Quality Control Check Report. Stage: After Finishing Stage III (Apartments)

Flat No	F-304	Other	—	Sl. No.	40742
Company	MRM-CLIP	Project	GMR	Phase	—
Prepared by	P. Bhargava	Sign	<i>P. Bhargava</i>	Date	28-10-22
Project Manager	Rampasud	Sign	<i>Rampasud</i>	Date	28-10-22
Previous stage report no.			40322	Report filed and signed by PM	☐ Yes ☐ No
Checked By MD on		MD Sign		For filling	☐ Yes ☐ No

GULMOHAR RESIDENCY

Details of Additions & Alterations

Choice of Bathroom tiles, CP fittings & Sanitary ware:

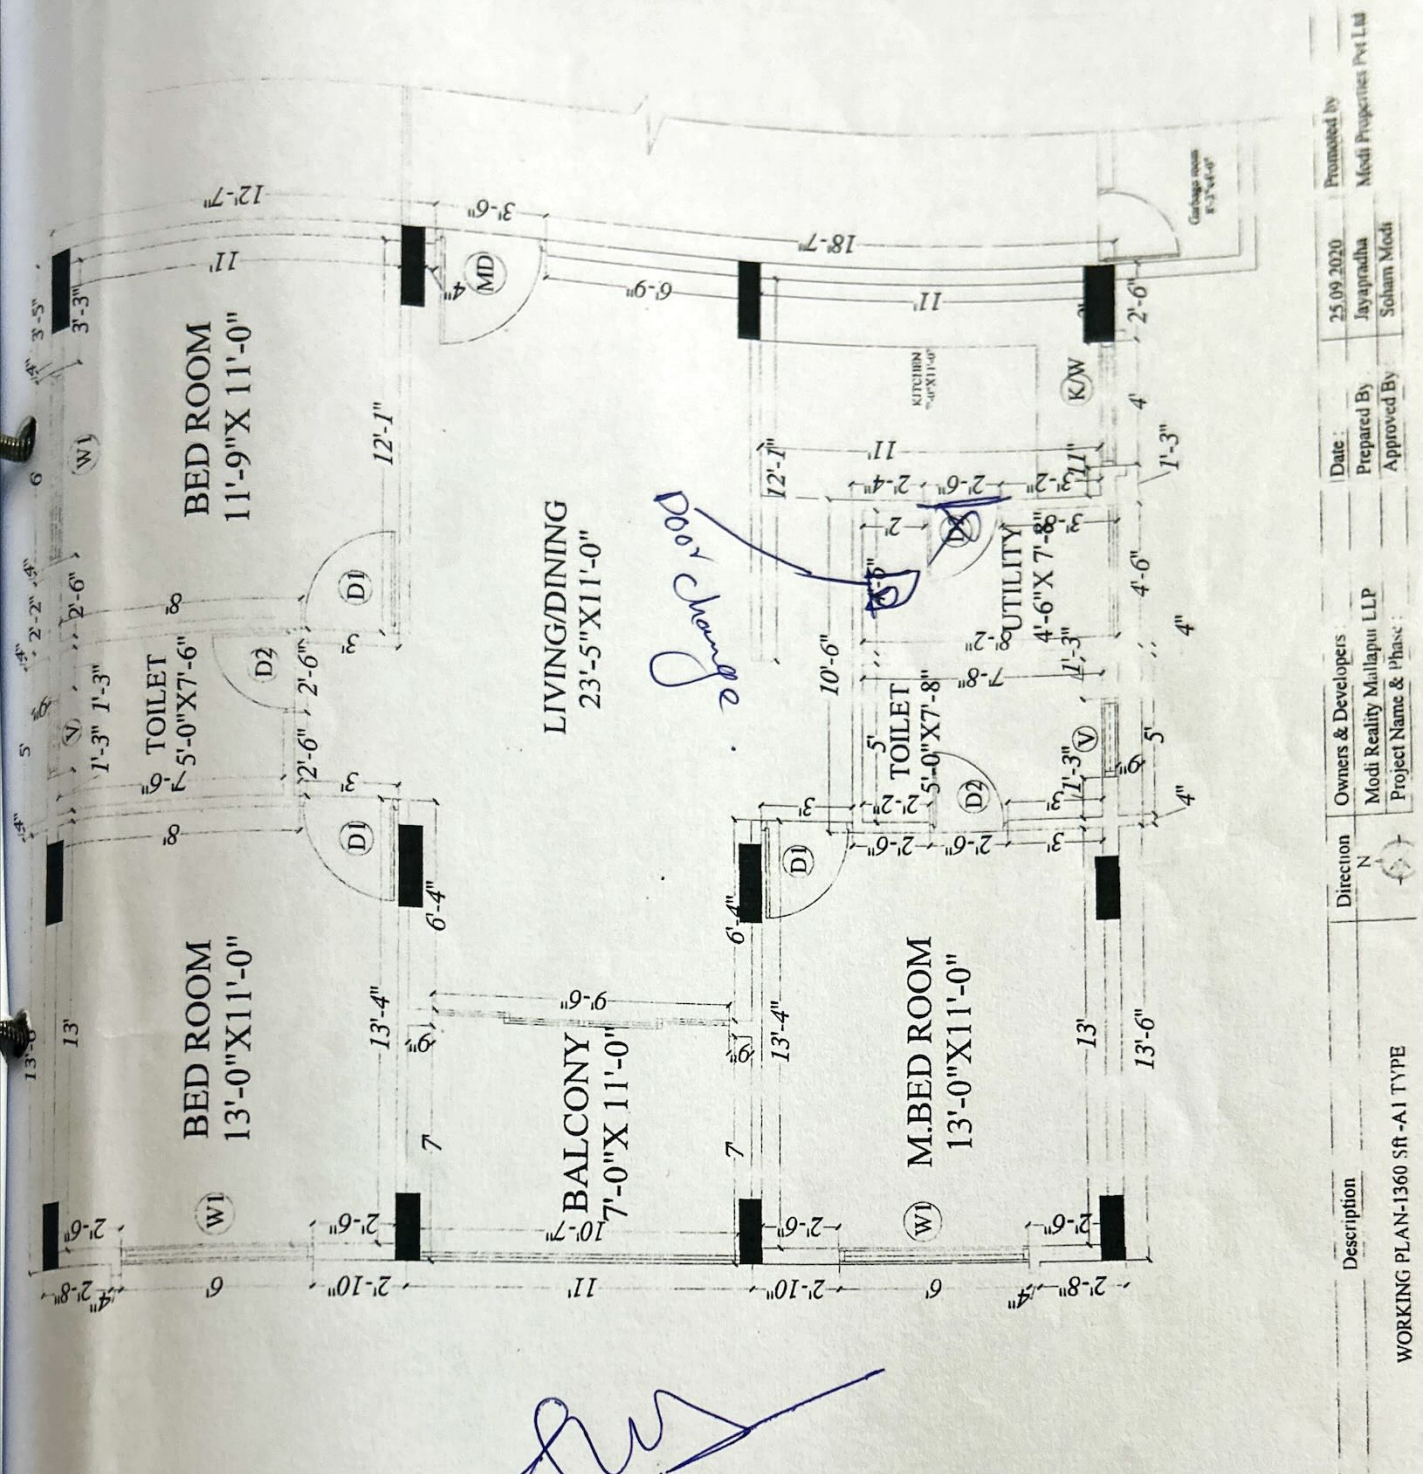
glass. partition in two bathrooms.

Description	Direction	Owners & Developers	Date	Promoted by
		Modi Reality Mallapur LLP	Prepared By	Modi Properties Pvt Ltd
		Project Name & Phase	Approved By	
		Scale		
		ELECTRICAL PLAN -1360 sq ft FLATS-A1 TYPE

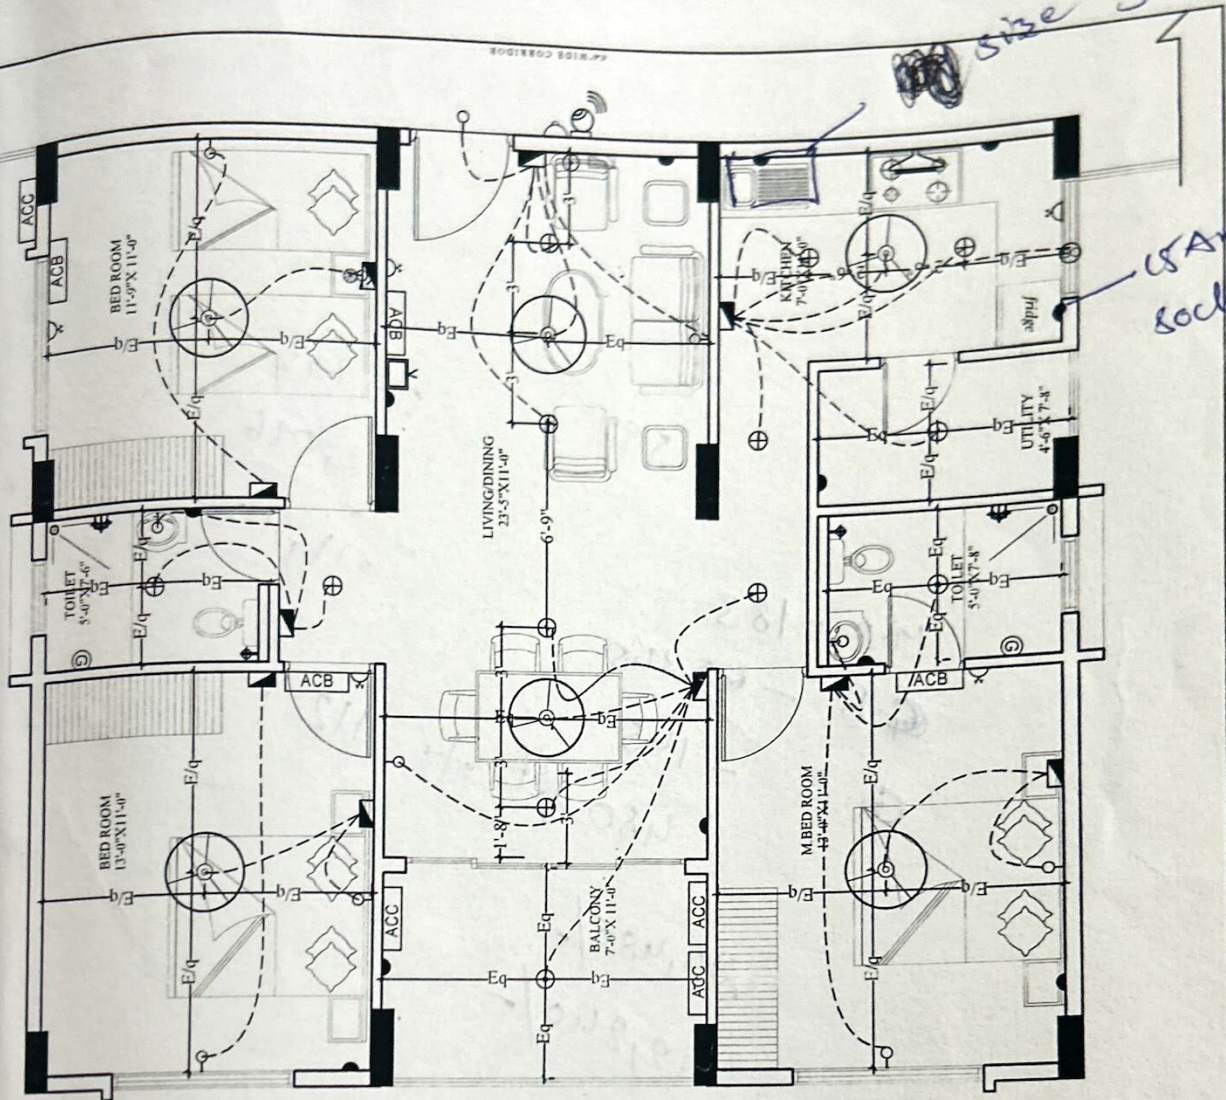
Changes in electrical points: (mark on plan)
